FINAL
ENVIRONMENTAL IMPACT REPORT

EL DORADO COUNTY
AIR QUALITY MANAGEMENT DISTRICT
DST Output West Printing Capacity
Expansion Project
(SCH # 2009082051)

November 2009

RESPONSES TO COMMENTS

Figure 4
 Carson Creek Unit 2 – El Dorado County, California
 DST Output Noise Measurement Sites and Noise Level Contours

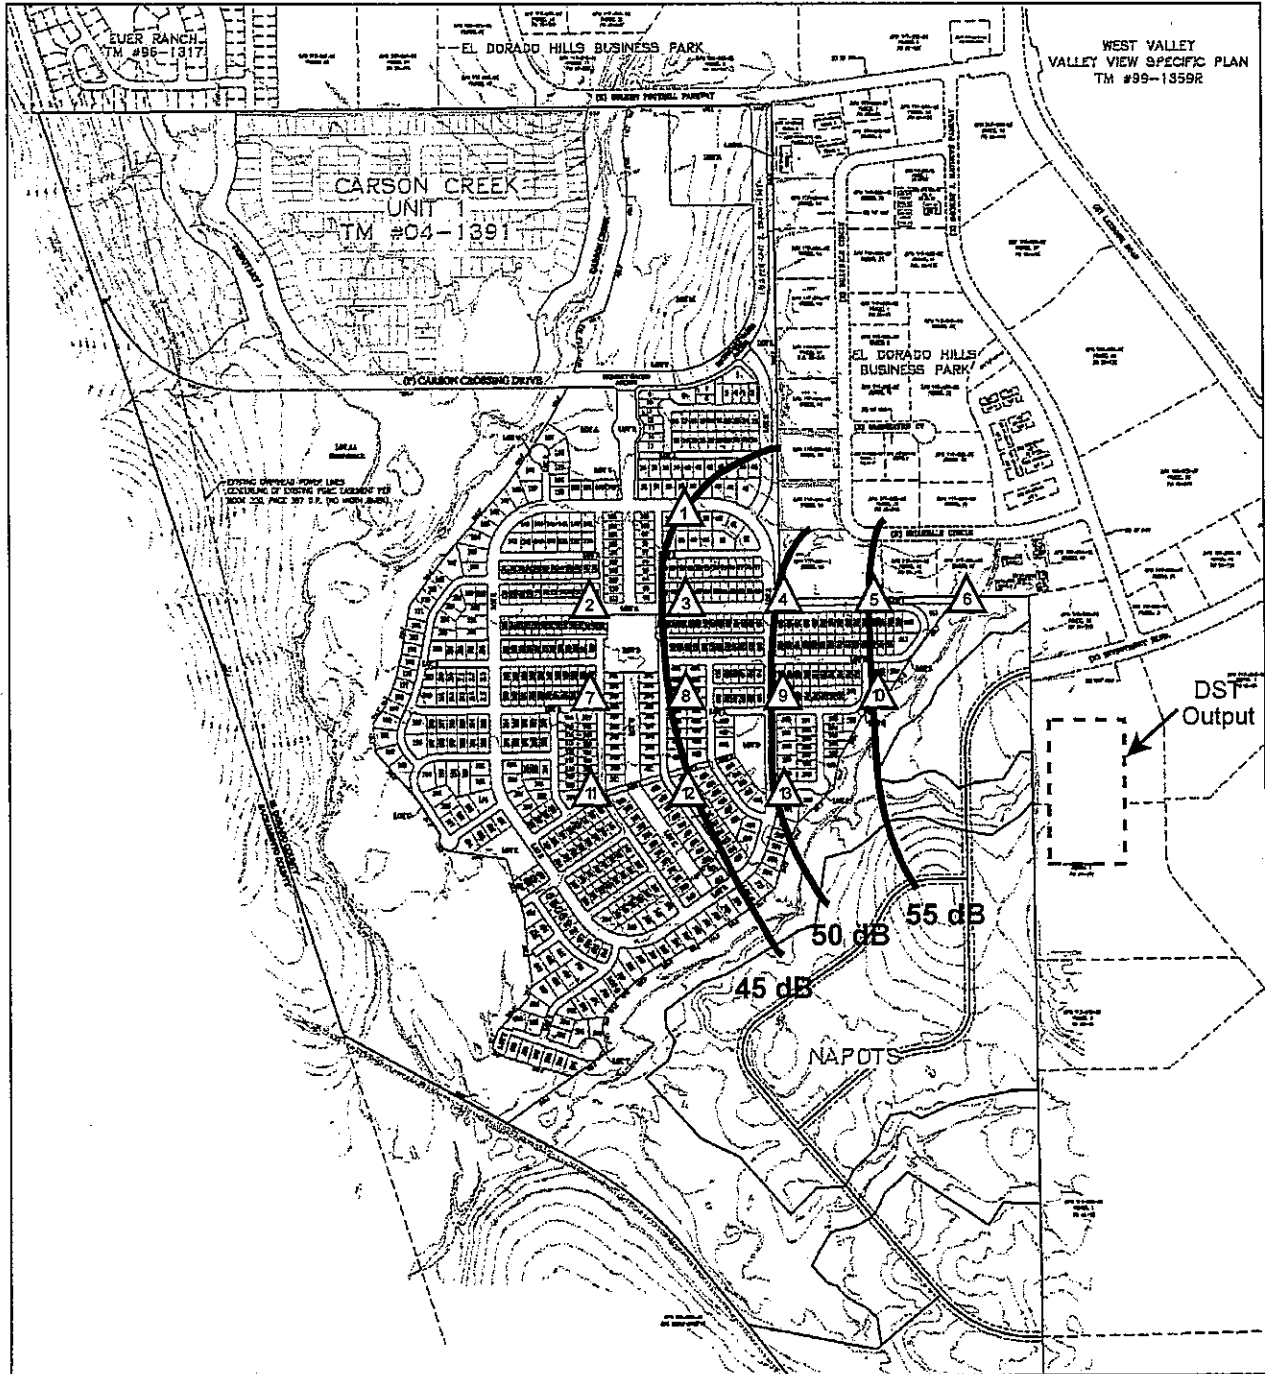
Based on the findings of the Environmental Noise Assessment, it would appear that the noise barriers at the existing DST facility are not adequately mitigating noise impacts to surrounding property owners, either under existing conditions or future conditions with the proposed expansion. Under CEQA Guidelines, a project is considered to have a significant noise impact if it results in the exposure of persons to or generation of noise levels in excess of standards established in the local general plan or noise ordinance. Therefore, noise impacts should be considered a significant impact and DST must be required to mitigate for the noise impacts.

Because operations at DST occur 24-hours per day, the appropriate standard to apply to this use would be the County's 45 dB L_{eq} nighttime standard. As can be seen from Figure 4, the 45 dB L_{eq} standard extends well into the Carson Creek Unit 2 project site. As a result, substantial noise mitigation measures would be required prior to the development of residences within that noise contour.

The second options is to restrict all residential development to locations outside of the 45 dB L_{eq} noise contour shown on Figure 4 until such time as the industrial noise control options cited above can be implemented or other mitigation has been determined.

In response to the concern raised by the commenter regarding the contribution of new project related noise to existing noise levels, an acoustical analysis dated November 11, 2009 was conducted by j.c. brennan & associates, Inc., consultants in acoustics. This analysis is found as Appendix A of the Final EIR. The analysis concludes that “based upon an interior noise level ranging from 90 dBA to 95 dBA due to overall future operations, the sound power level at the exterior building façade would be approximately 51 dBA to 56 dBA. The property line of the DST facility is 50 feet from the nearest building façade. Based on a conservative attenuation rate of 10 dB per doubling of distance, the noise levels associated with the operations inside of the building will be less than 40 dBA Leq at the east property line. Therefore, the interior operations of the project will comply with the El Dorado County exterior noise level criterion of 45dBA Leq.”

The DST building façade construction is a tilt-up concrete system. Transmission loss data indicates that the tilt-up concrete façade will provide a minimum transmission loss of 39 dBA at the 125 Hz octave band. Transmission loss of the building façade increases with the higher frequencies. Based upon an interior noise level ranging from 90 dBA to 95 dBA due to overall future operations, the sound power level at the exterior building façade would be approximately 51 dBA to 56 dBA. The property line of the DST facility is 50 feet from the nearest building façade. Based upon a conservative attenuation rate of 10 dB per doubling of distance, the noise levels associated with the operations inside of the building will be less than 40 dBA Leq at the east property line. Therefore, the interior operations of the project will comply with the El Dorado County exterior noise level criterion of 45 dBA Leq.
